ADDENDUM NO. 2

**GMIA – RUNWAY GUARD LIGHT REPLACEMENT
IN-PAVMENT & ELEVATED
PROJECT NO. A123-14005**

OFFICIAL NOTICE NO. 6901

GENERAL MITCHELL INTERNATIONAL AIRPORT
Milwaukee County, Wisconsin

BASE PLATE DETAIL

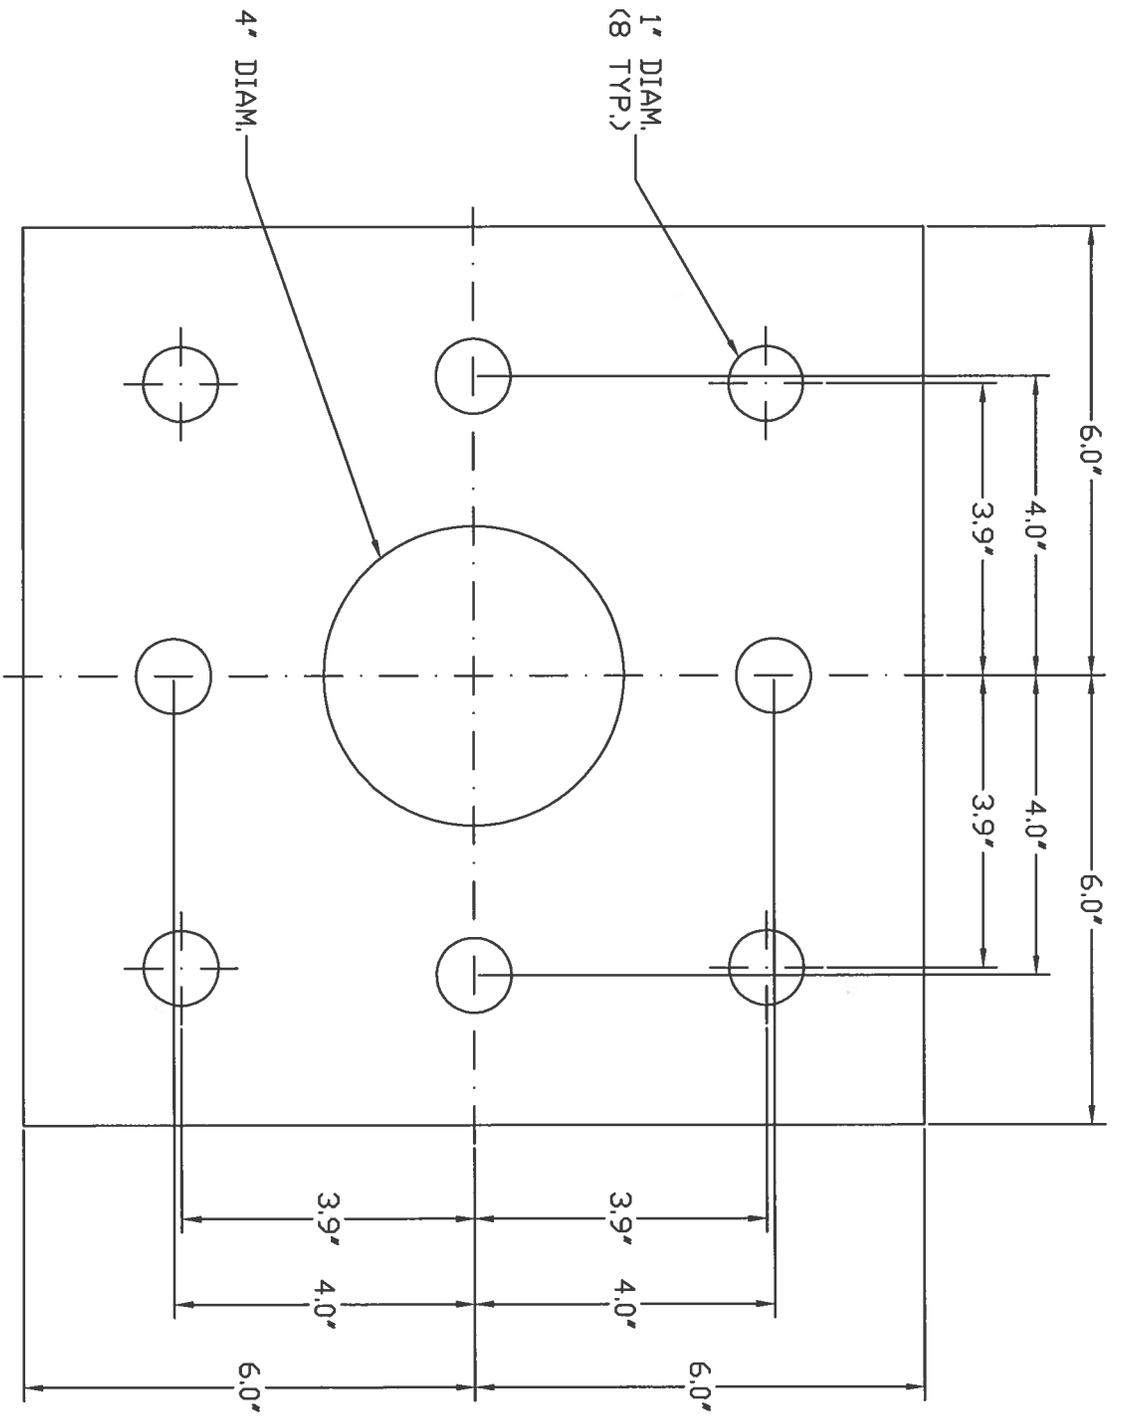
Detail: "Primary Wind Cone Foundation" Substitute enclosed foundation base plate detail onto proposed wind cone foundation.

NOTE: ONLY 4 ANCHOR BOLTS REQUIRED
